Heels in VAE Switches

The heel arrangement for VAE tangential switches has changed.

Figure 2 Old VAE switch design

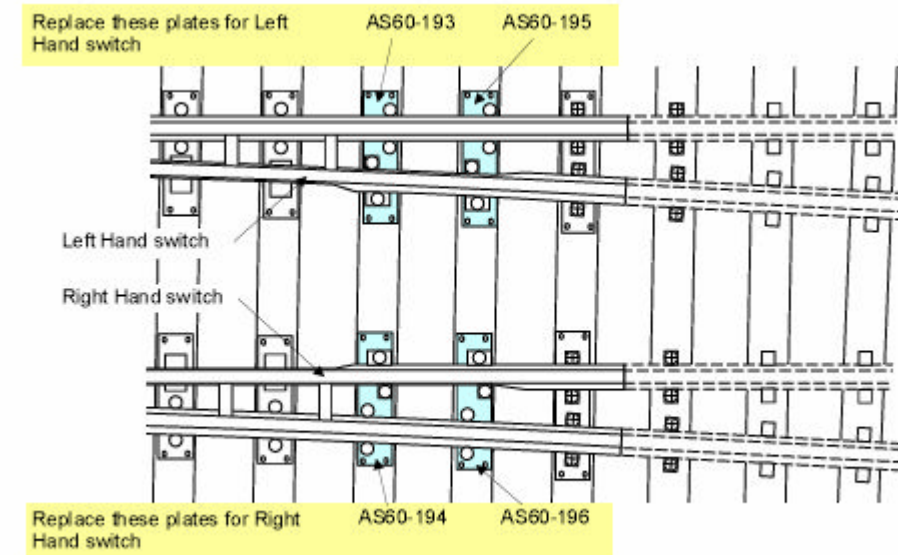
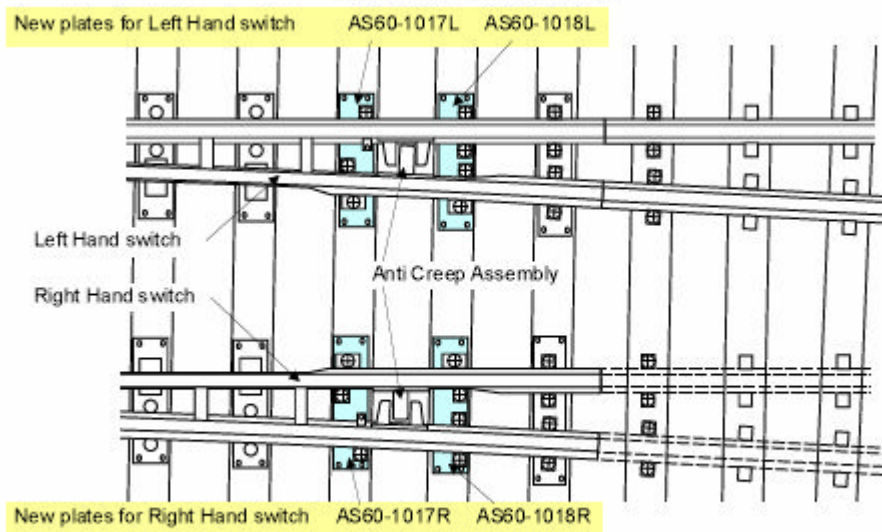
In the new design a heel arrangement is fitted. The plating for this is also different.

When a replacement switch or stockrail is required for the old design a complete switch & stockrail assembly to the new design must be used. The assembly will include the anti creep assembly but staff must separately order new plates for the affected area. These must be installed in accordance with the relevant drawing.

The standard design detail is shown in Figure 2 (old design) and Figure 3 (new design). For other layouts consult the ARTC Standards & Systems department.
